Addendum No. 01

Subject: John Taggart ES – Classroom Modernization

SDP Contract Nos. B-047C, B-050C, of 2017/18

This Addendum, dated 9th of May, 2018, shall modify and become part of the Contract Documents for the work of this project. Any items not mentioned herein, or affected by, shall be performed strictly in accordance with the original documents.

DRAWING 14.3 - LARGE SCALE LAYOUTS - CLASSROOMS

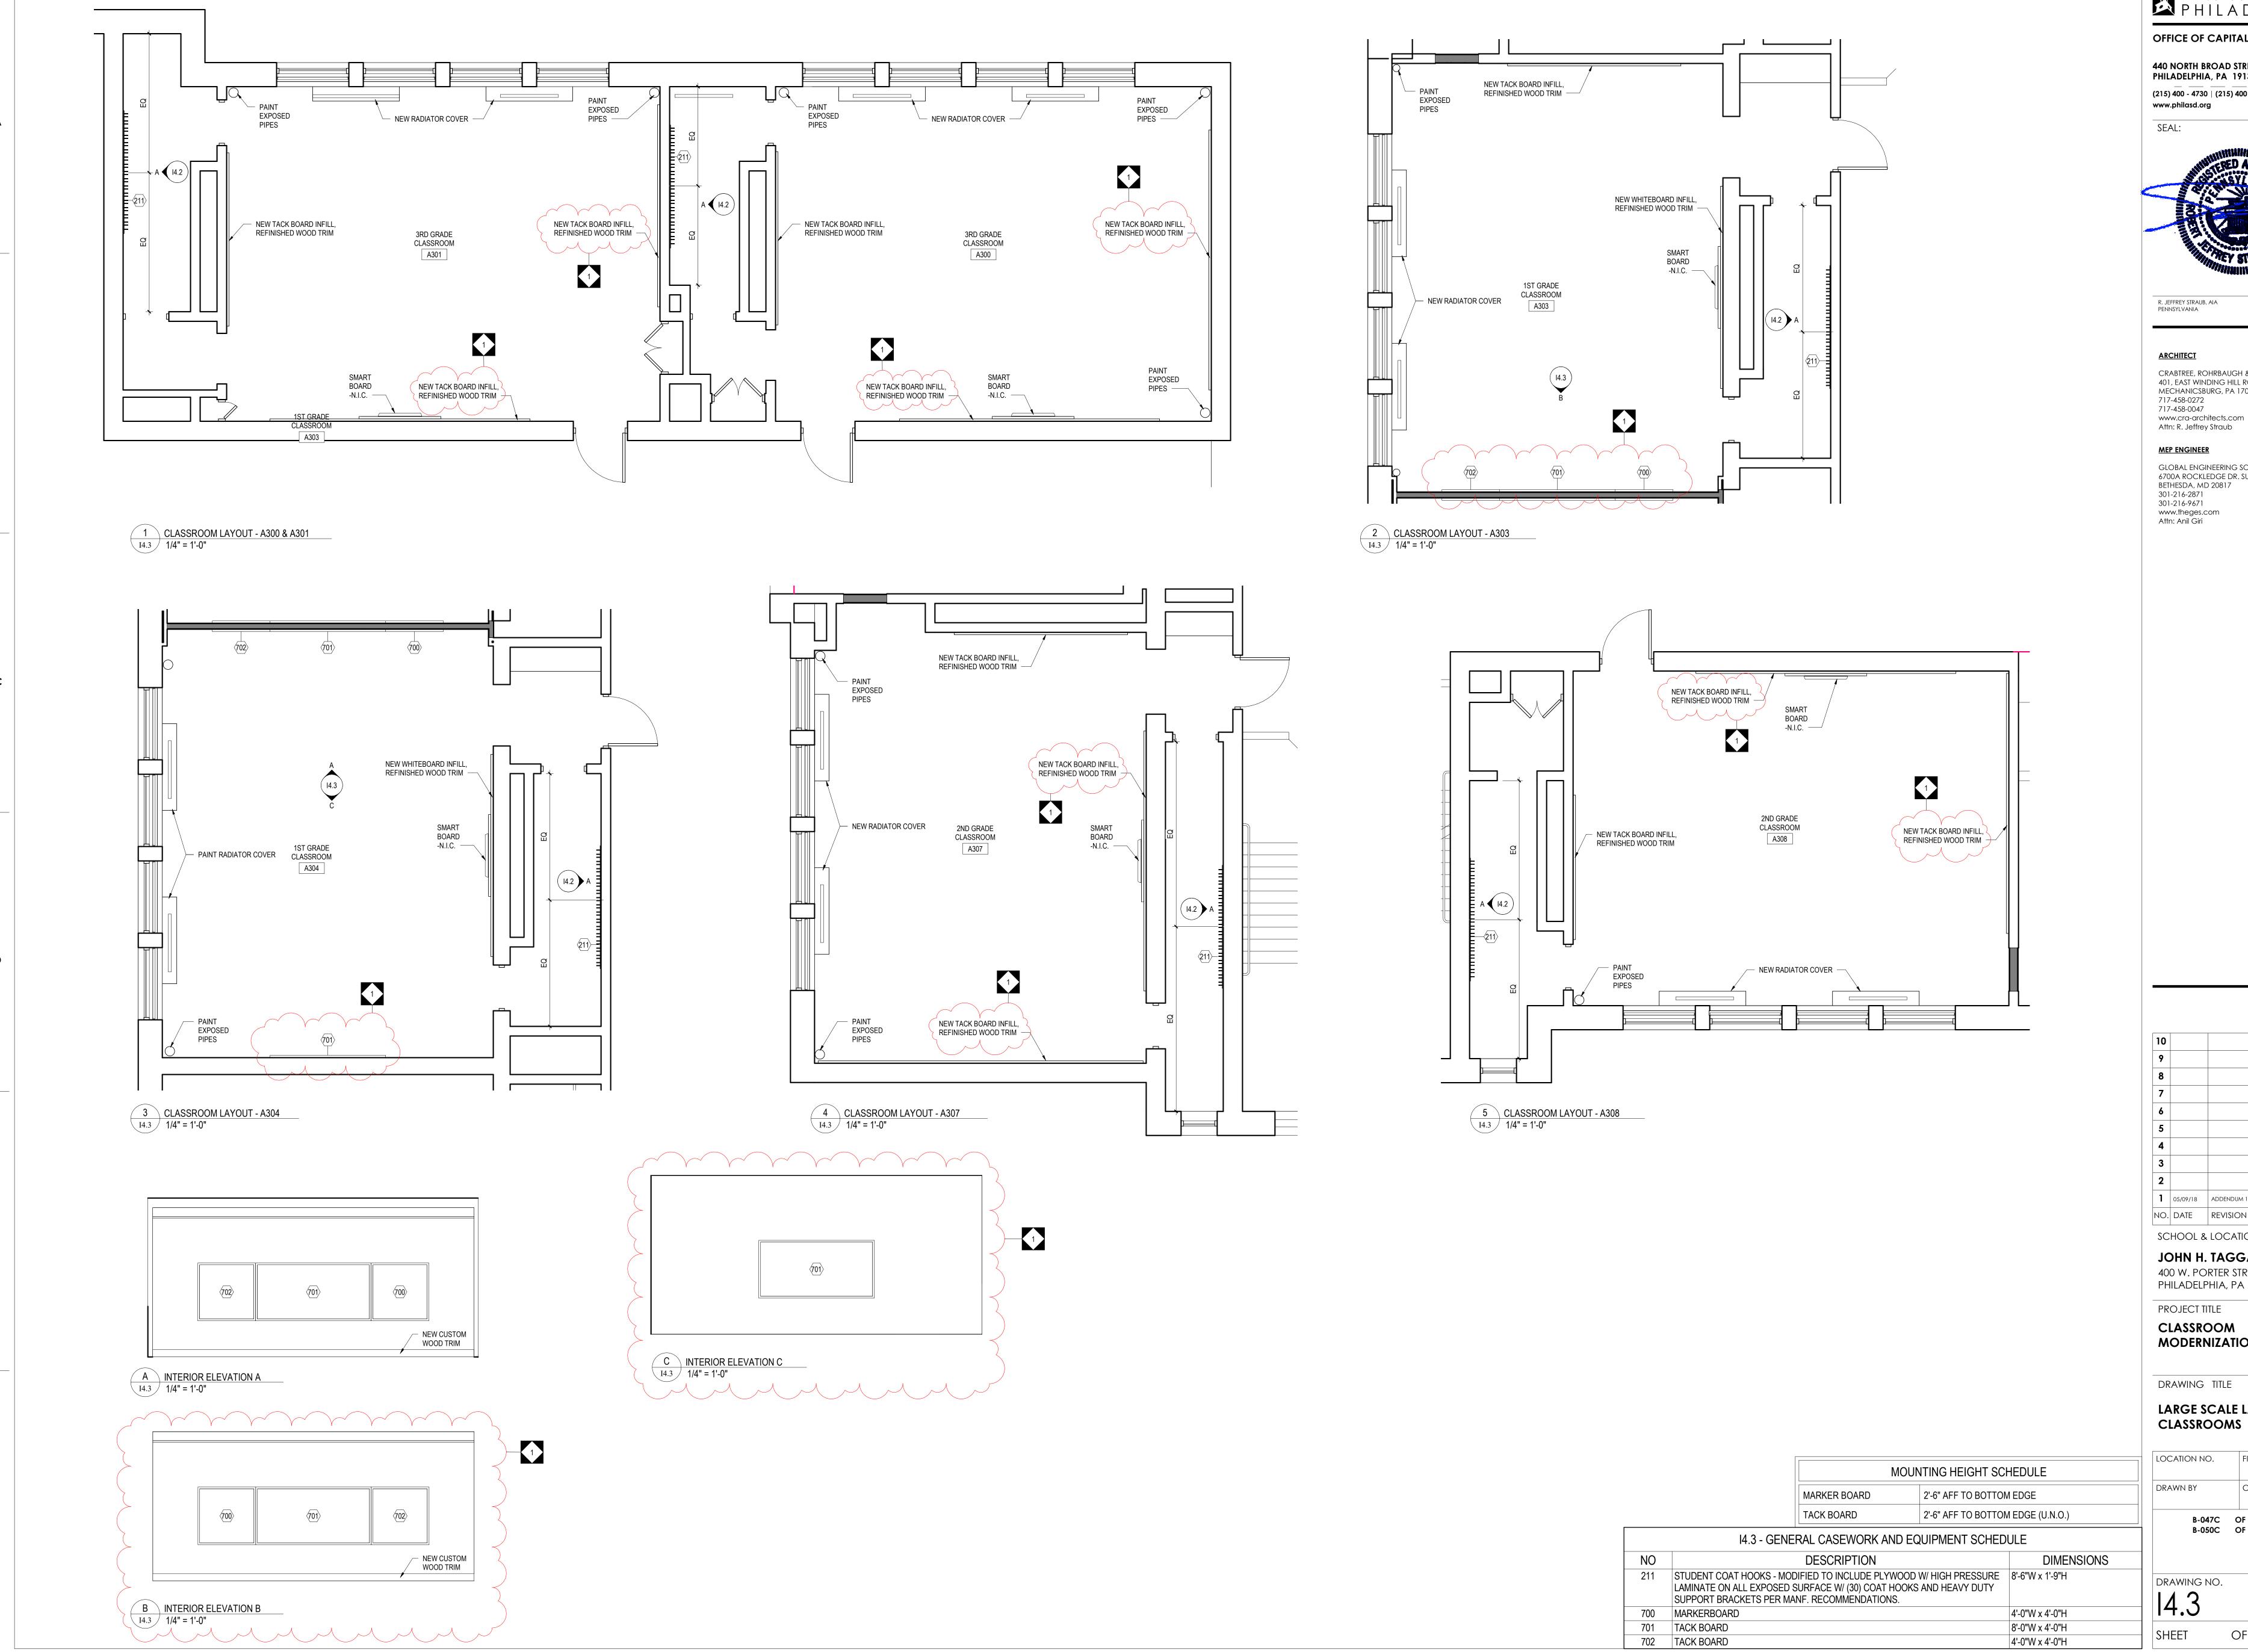
- ADD tack strip and markerboard.
- 2. **REVISE** whiteboards to tack boards.

DRAWING PD111 - FIRST & SECOND LEVEL - PLUMBING FLOOR PLAN - DEMOLITION

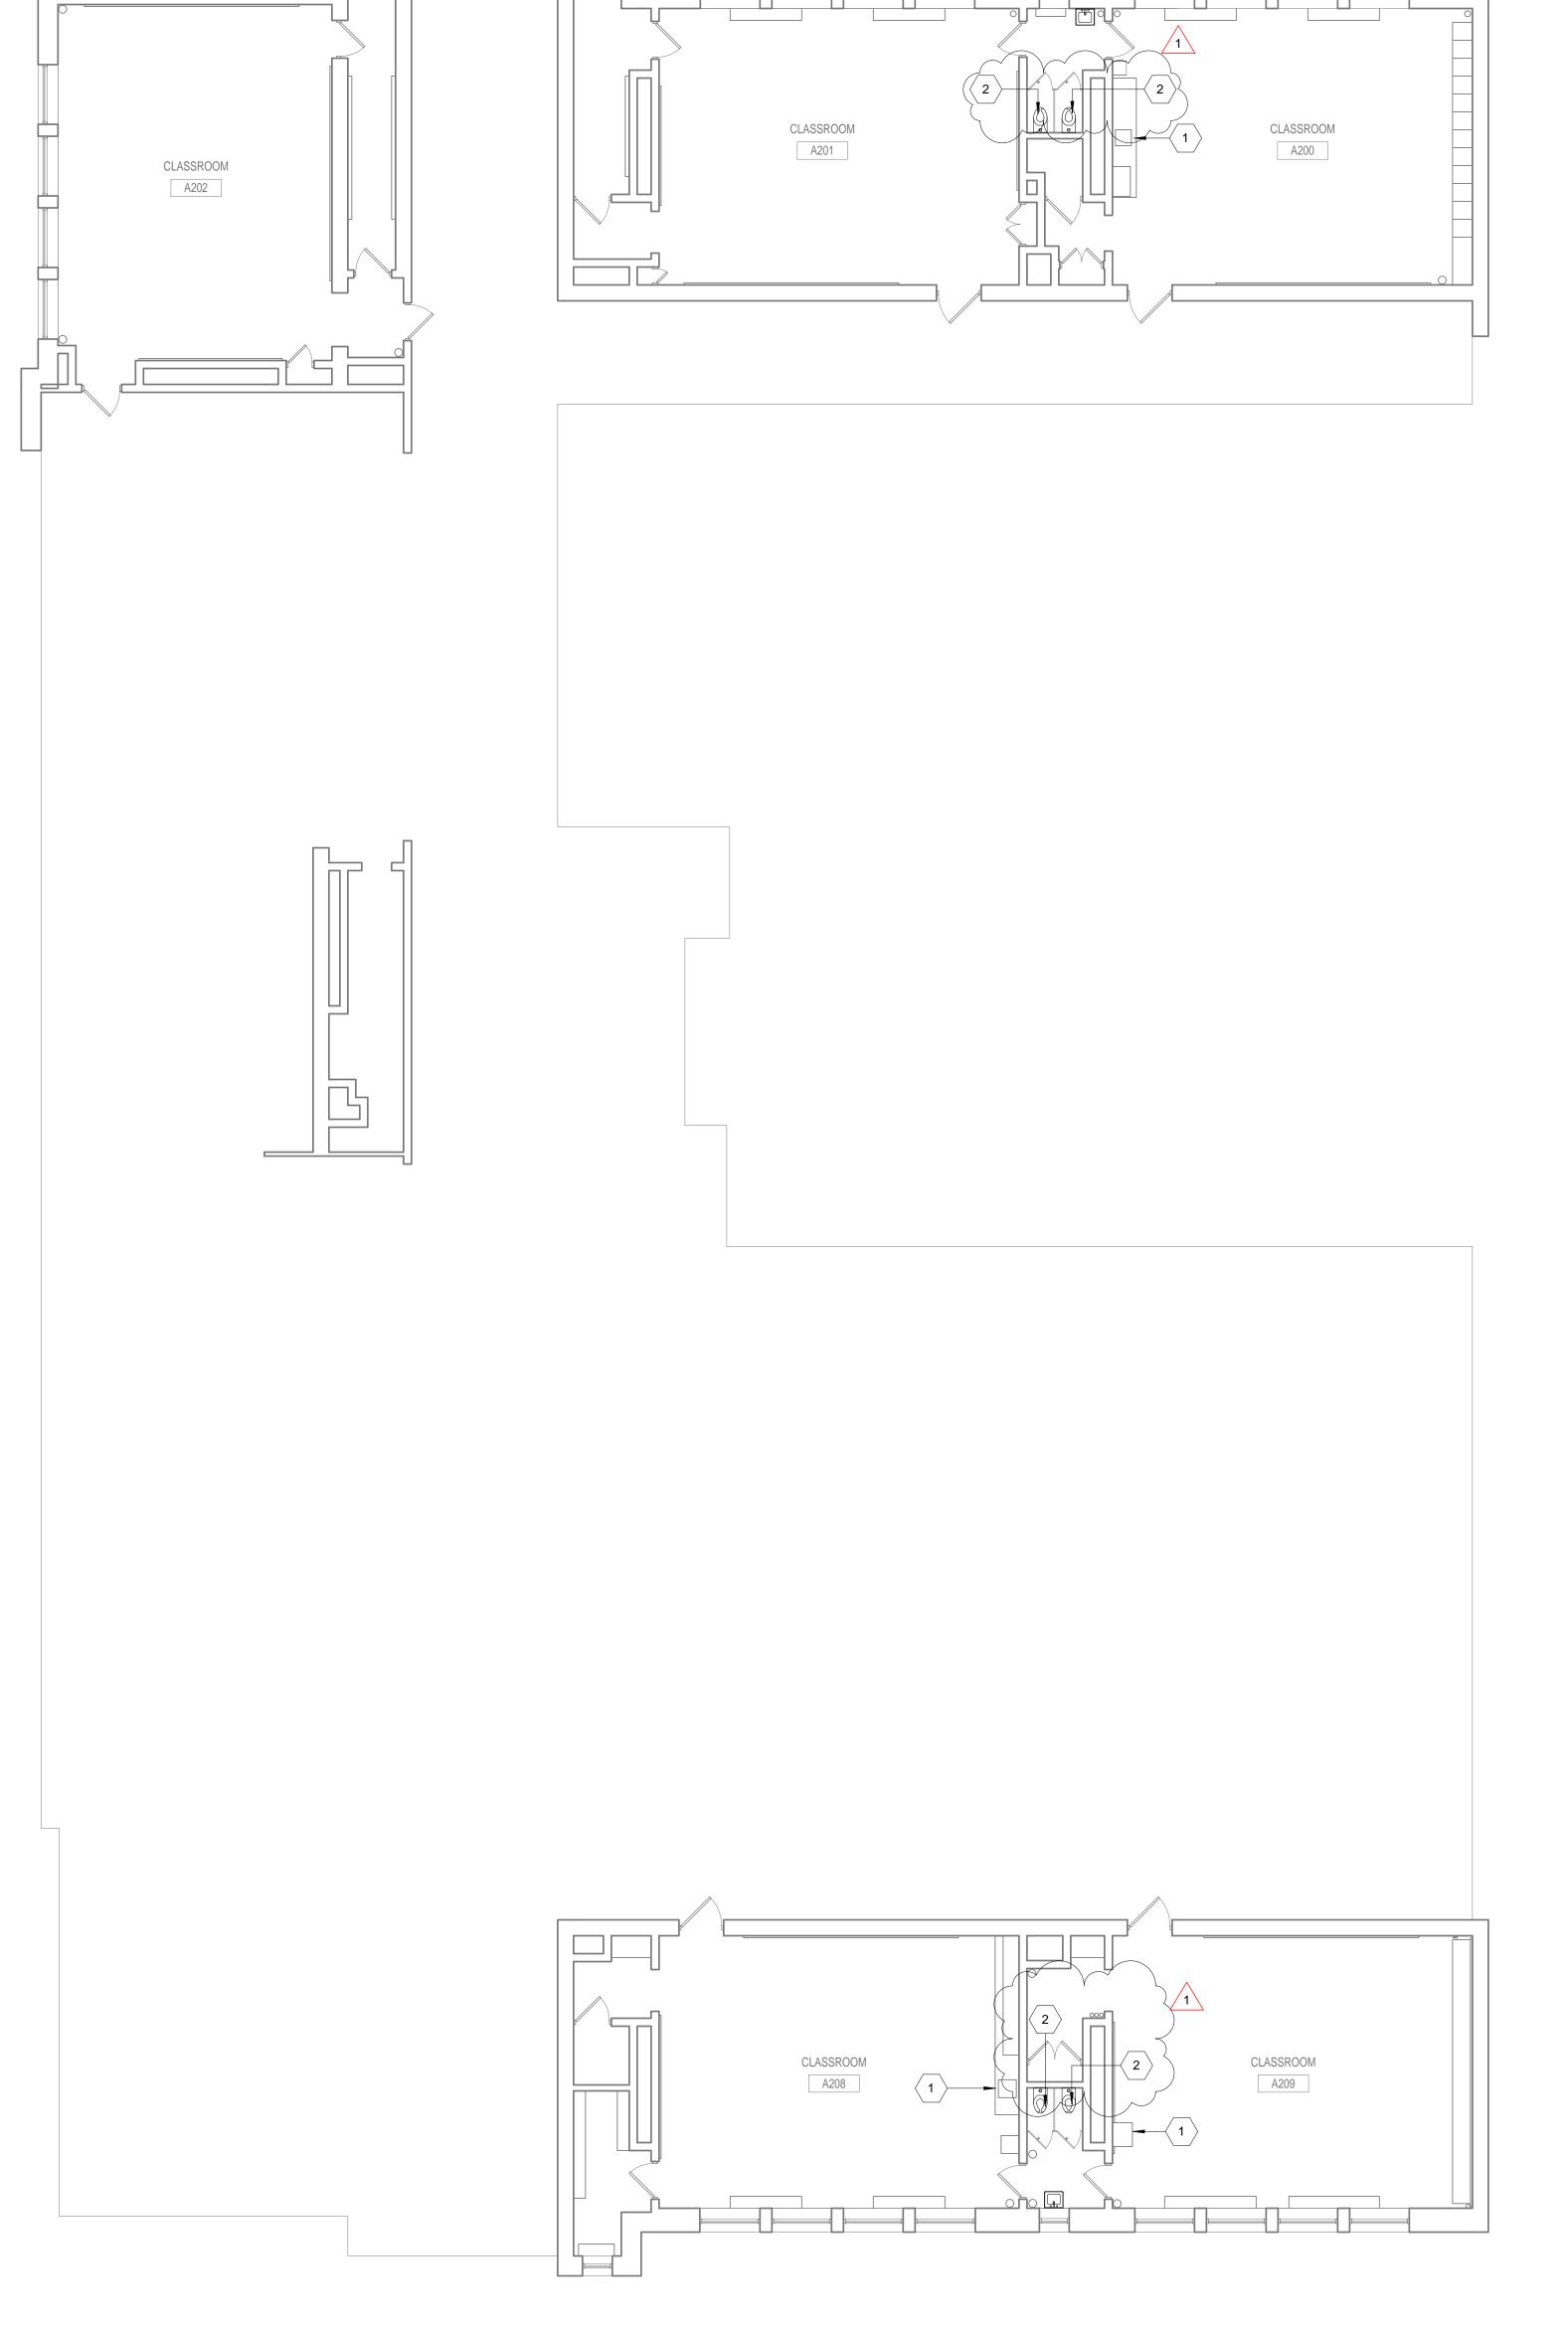
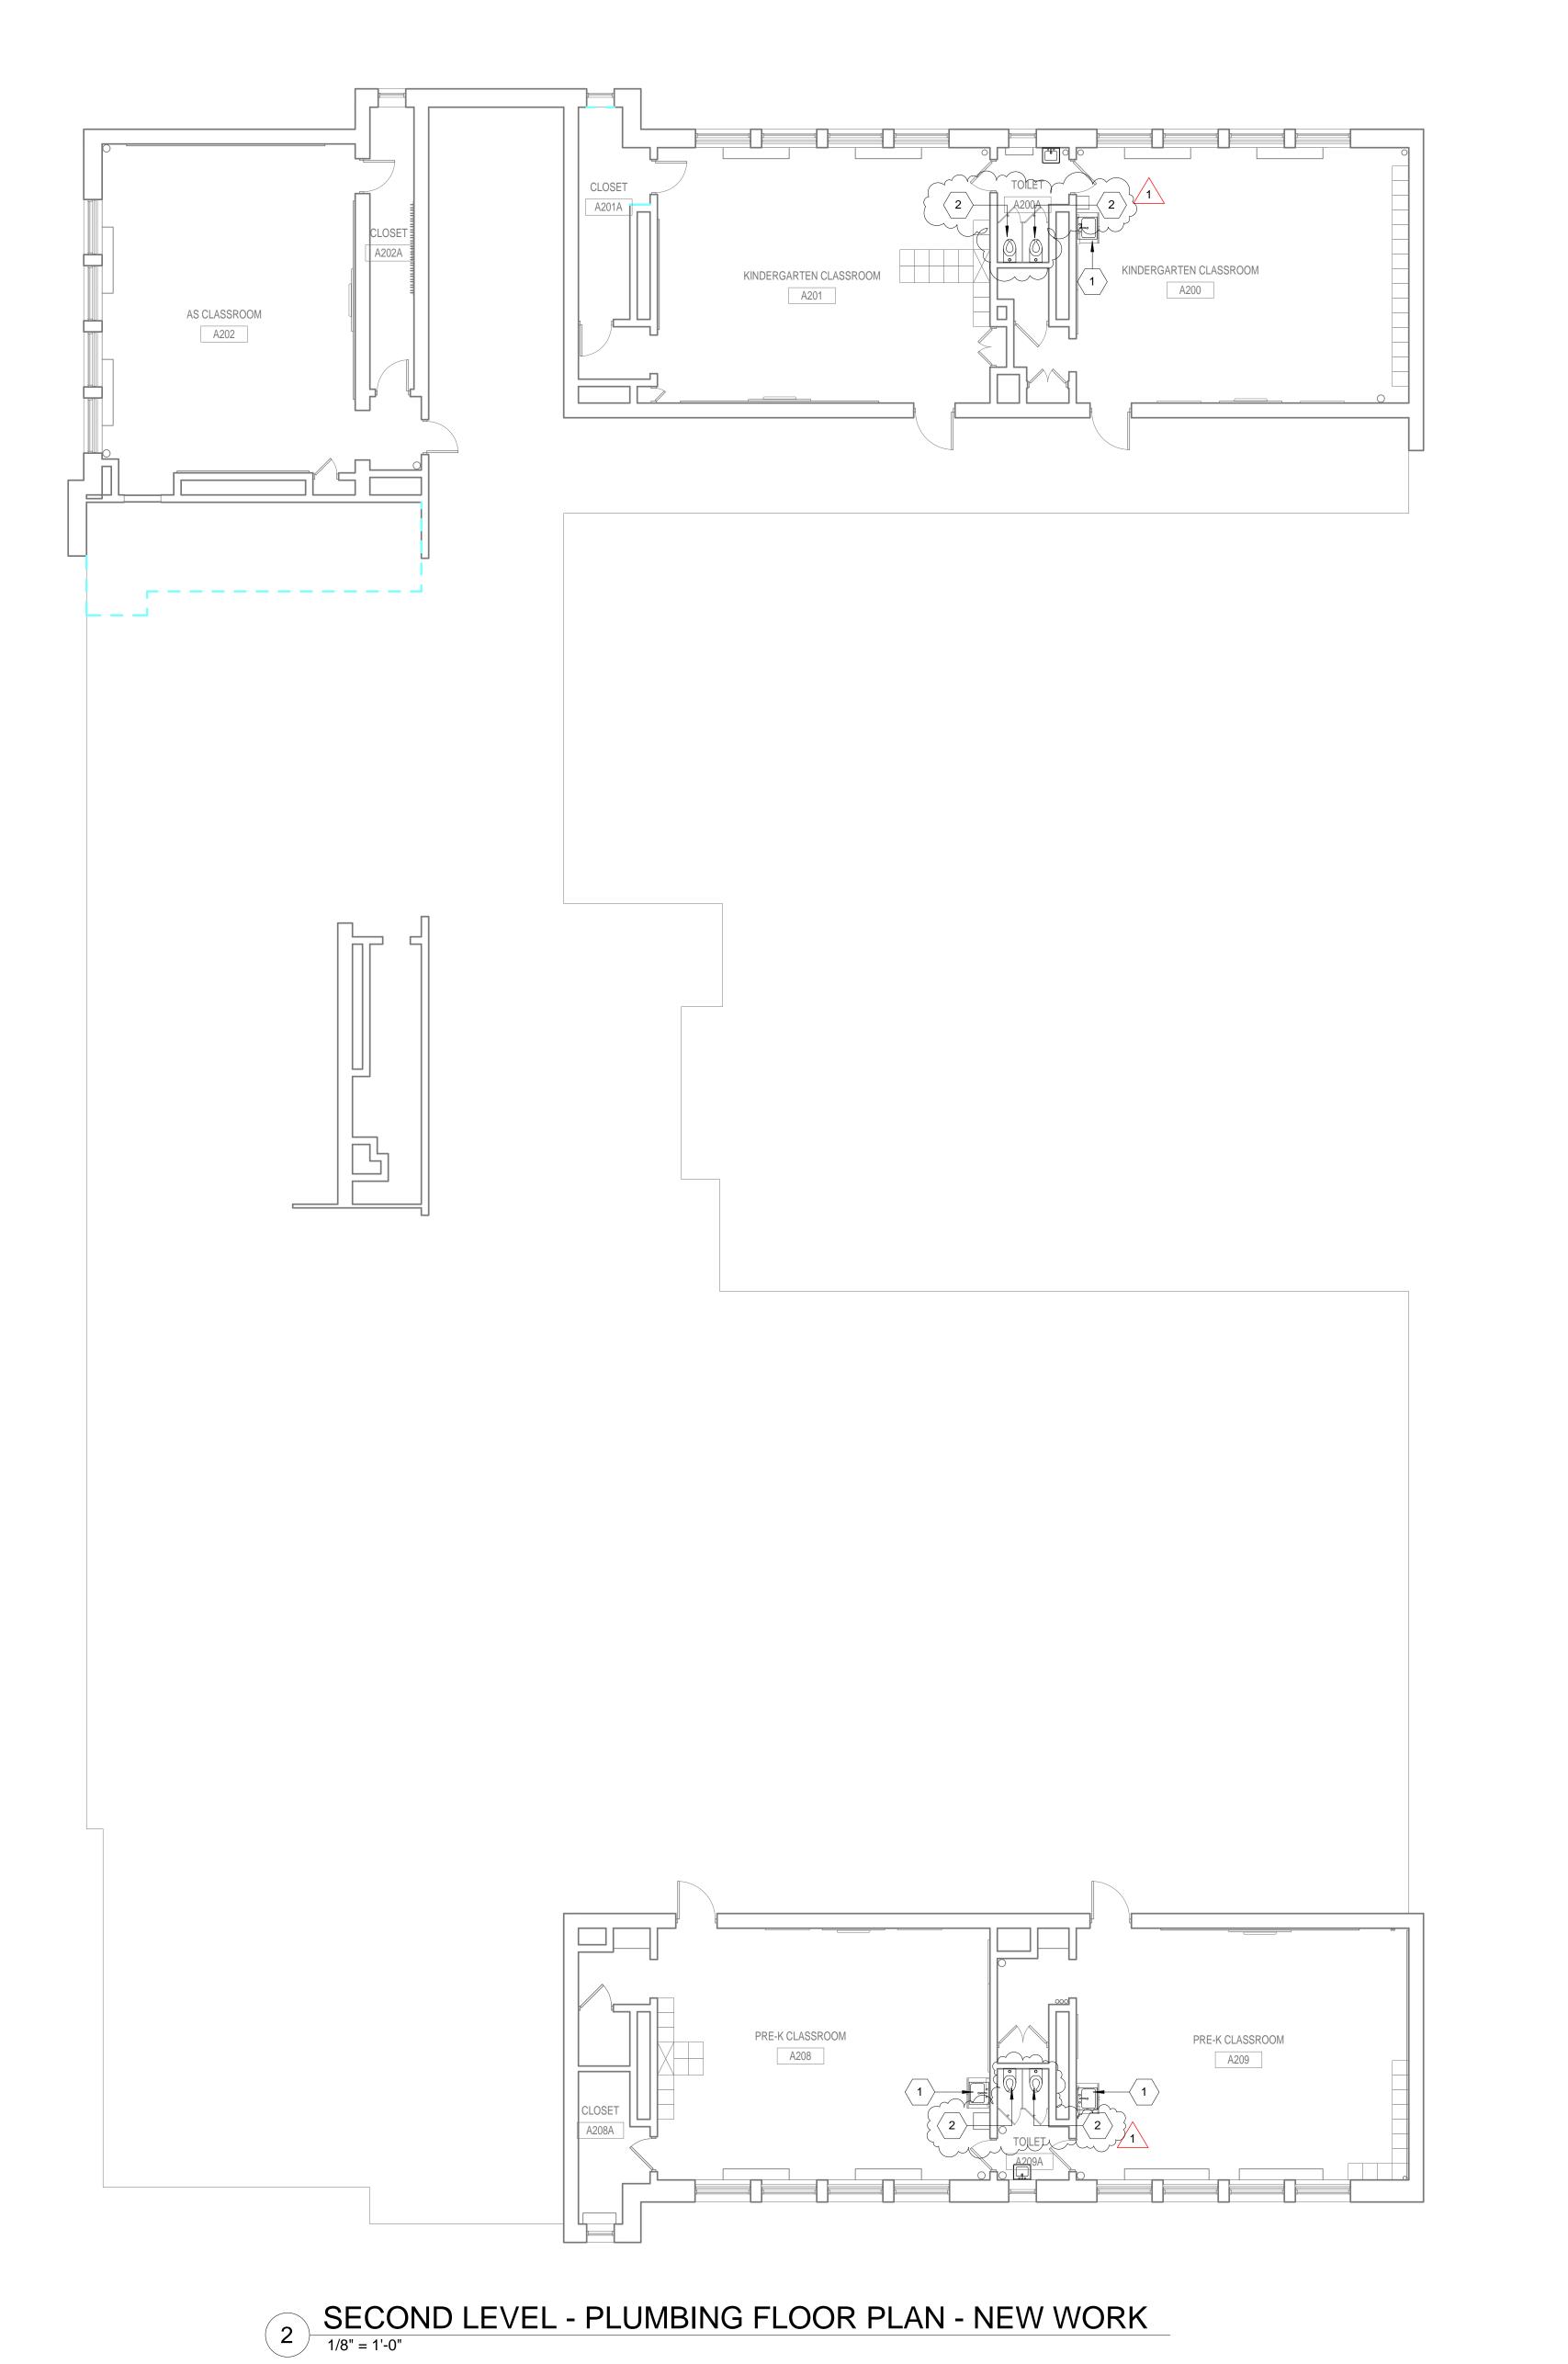
1. **ADD** demolition key note 2.
